**Portland General Electric Company**  
Trojan Nuclear Plant  
71760 Columbia River Hwy  
Rainier, OR 97048  
(503) 556-3713

VPN-004-2005

Revision 20 of PGE-1061, "Trojan Nuclear Plant Defueled Safety Analysis Report and License Termination Plan (PGE-1078)" (a.k.a., TNP Decommissioning Plan)

### Description of Changes

<p>Trojan Nuclear Plant DECOMMISSIONING PLAN</p>
<p>Figure 2-1a Site Plan Revision 20</p>

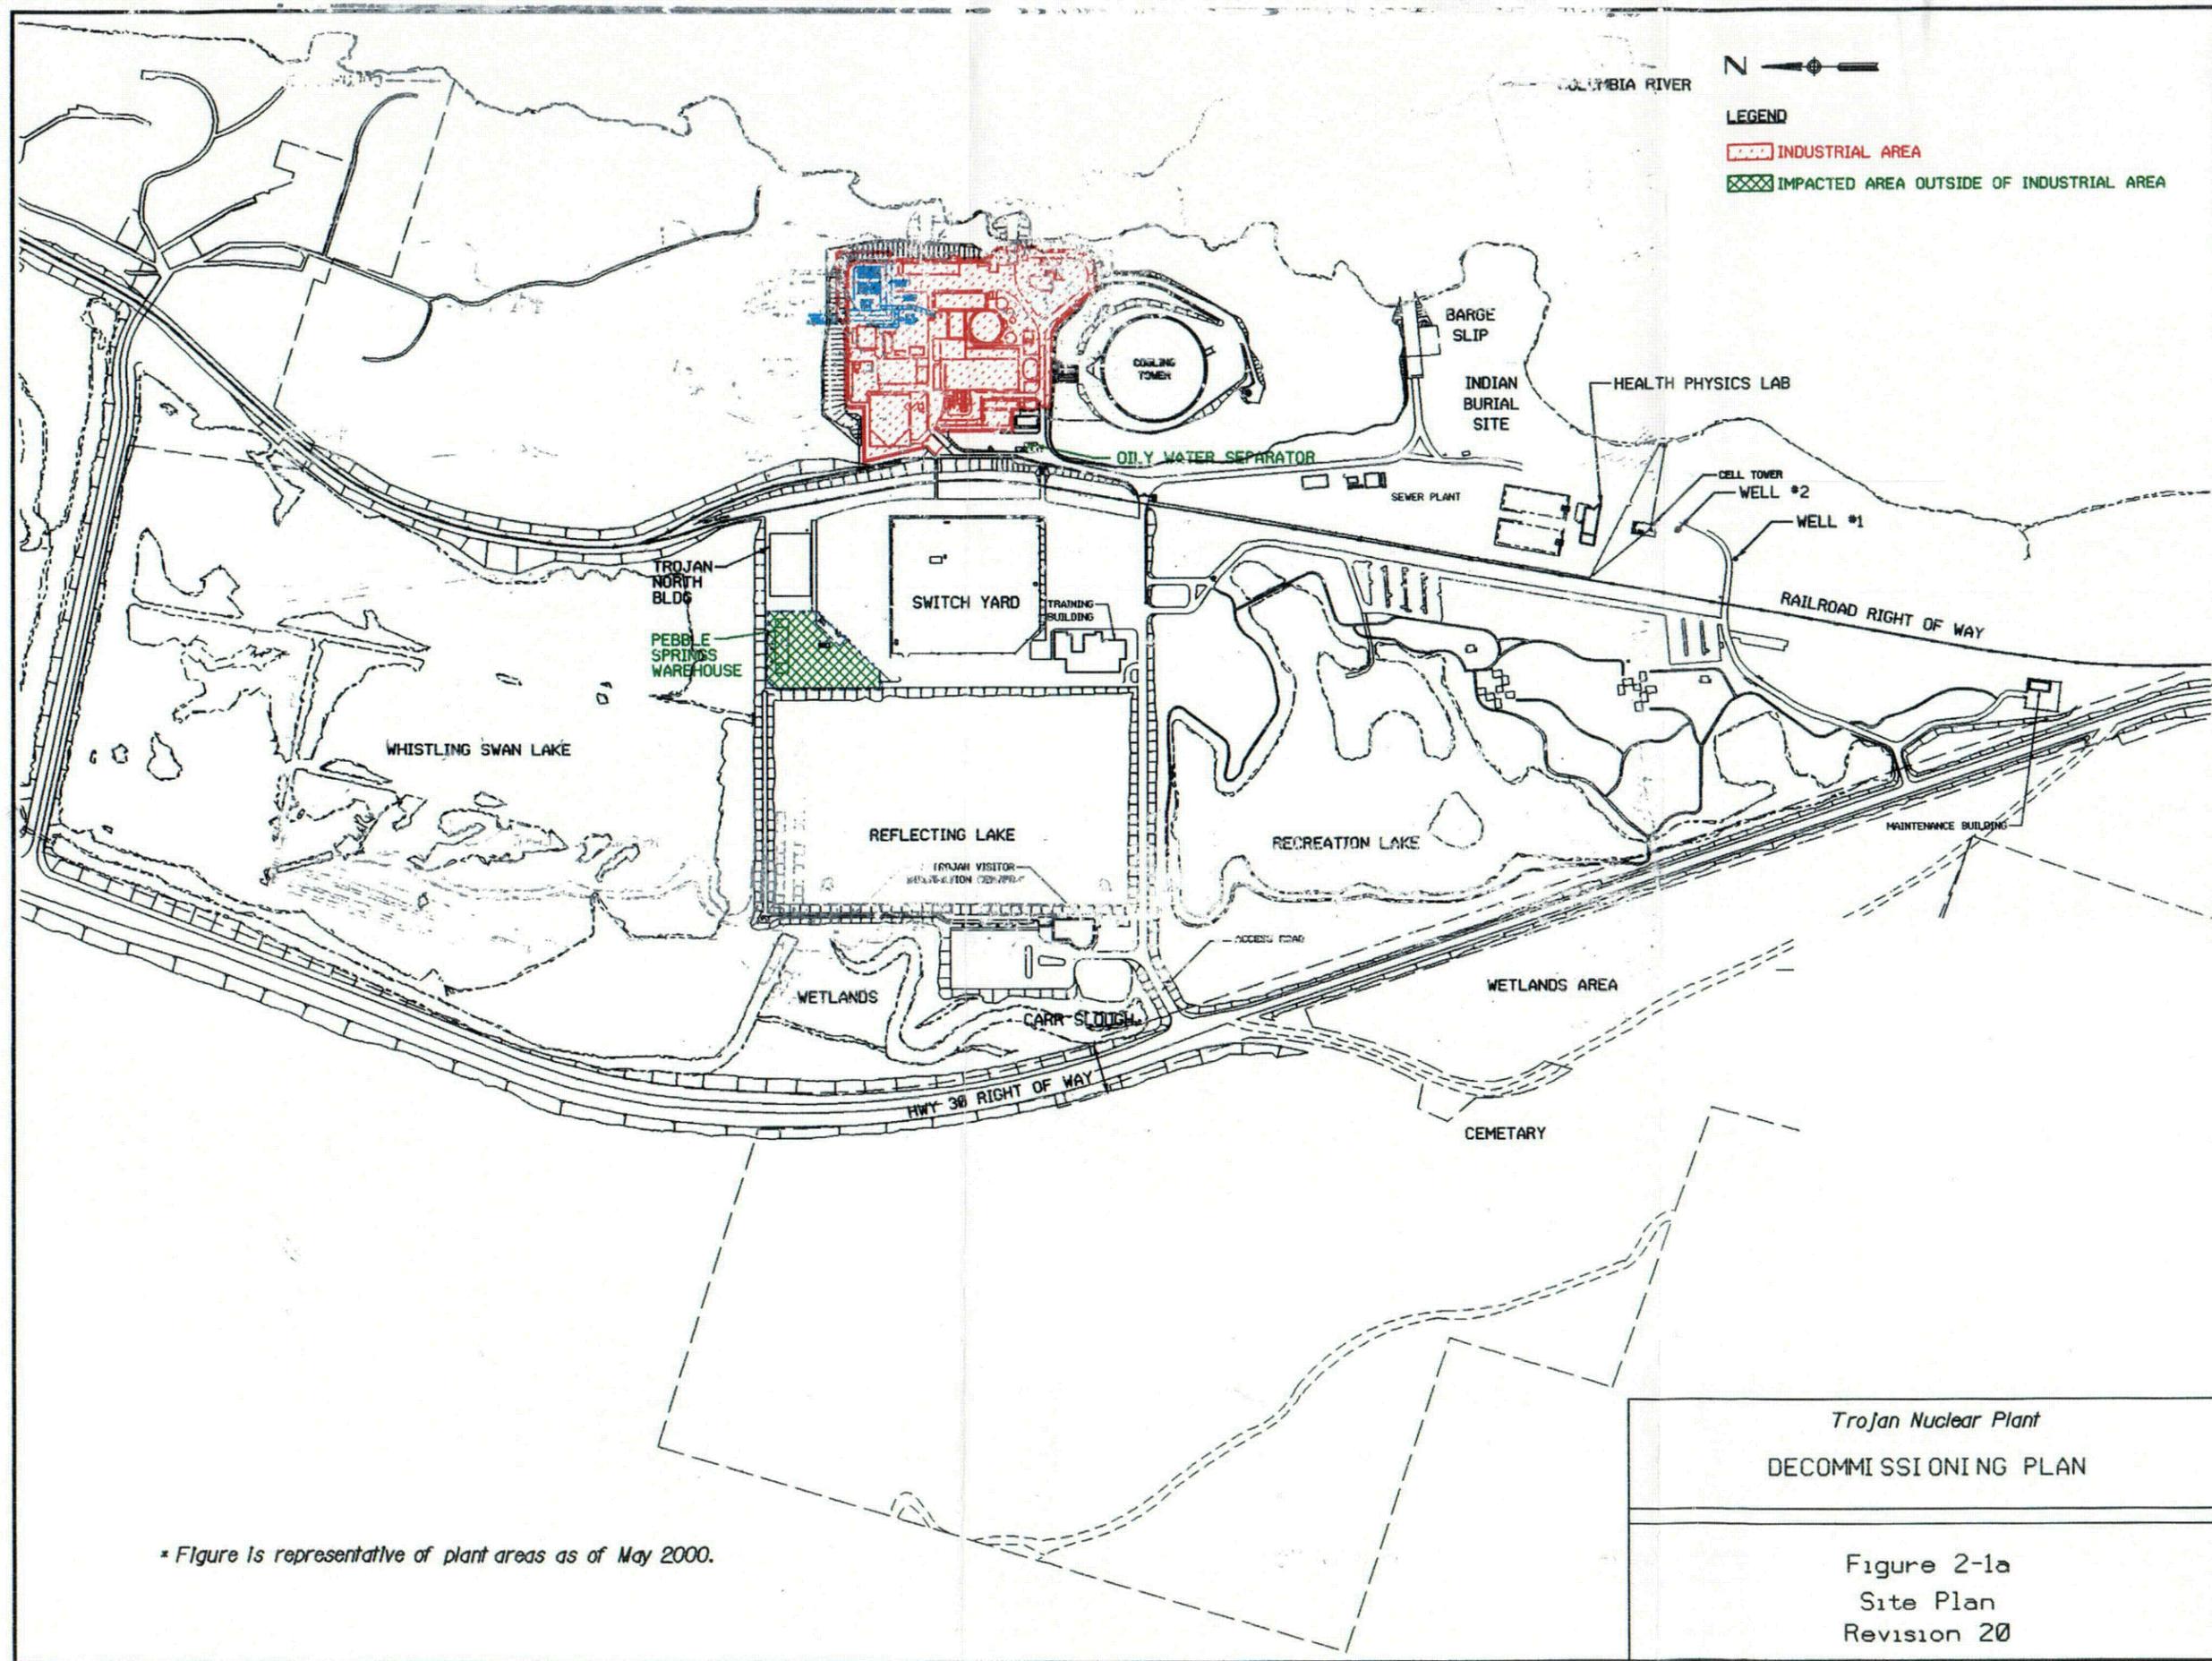
LDCR 2004-021      Figure 2-1a is revised to reflect that the area immediately surrounding the Cooling Tower is not considered a radiologically impacted area. The area had previously been considered for possible temporary storage of low-level radioactive waste shipping packages while awaiting shipment to an off-site disposal facility. However, the area was not used in such a manner and its original classification as a non-impacted area remains applicable. This change is administrative in nature.
